PD Behavior during PSE Transient

D1.2 comment # 232, v4

Fred Schindler, Seen [Simply](#)

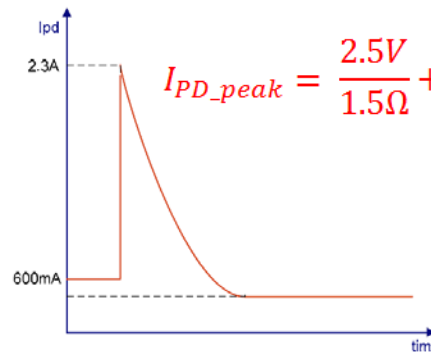
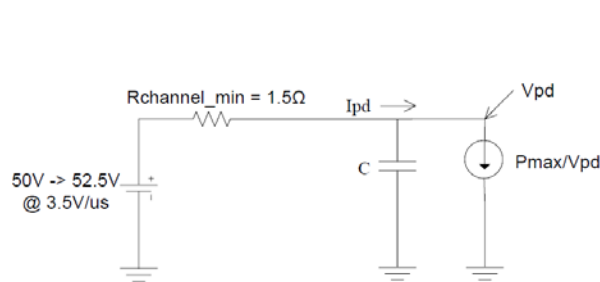
- Transients above 3.5V/us may affect Ethernet data integrity. A PSE will limit dv/dt below this level. PD requirement ① prevents the PSE from exceeding ILIM after TLIM.
- Equipment tests established dv/dt rates for ② are less than 2,250 V/s and requirement ② prevents the PSE from exceeding ILIM after TLIM.

Figure 33-18—PD static operating mask

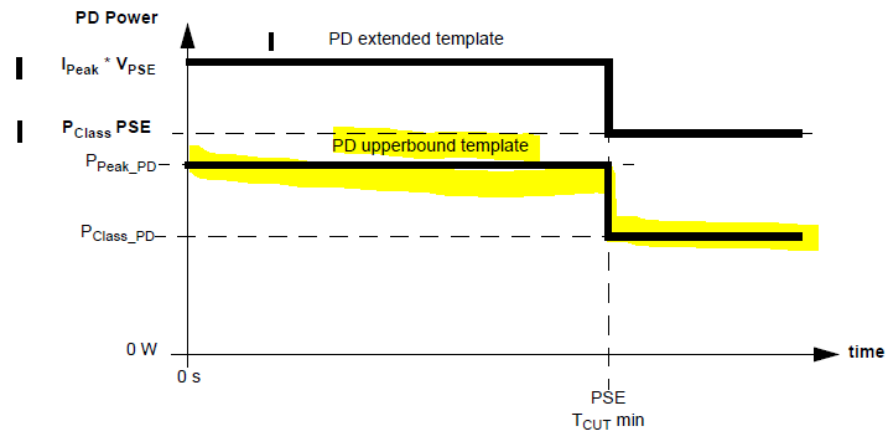
- The existing PD static operating mask is for the total PD power.
- DS PD should have the same class value on each Mode. DS PDs were tested the same as SS PDs.

Replace Figure 33-18 with the following figure:

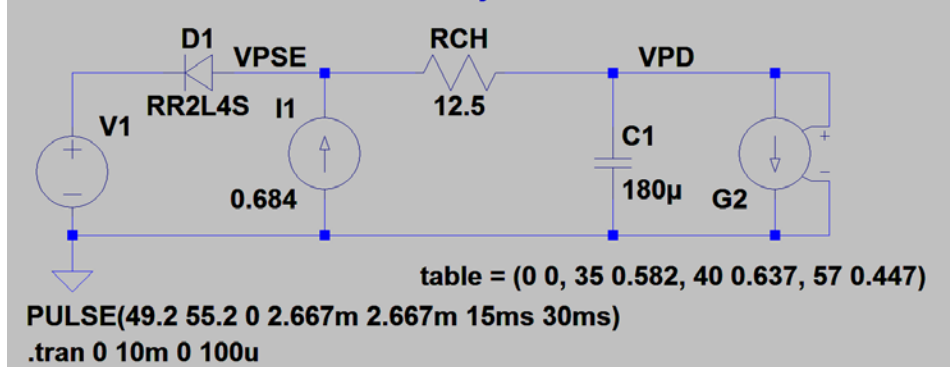
Strike Editor's Note,

“2. A drop out specification needs to be added to this section that requires PDs to ride out PSE transients. This is in place of increasing Cport.
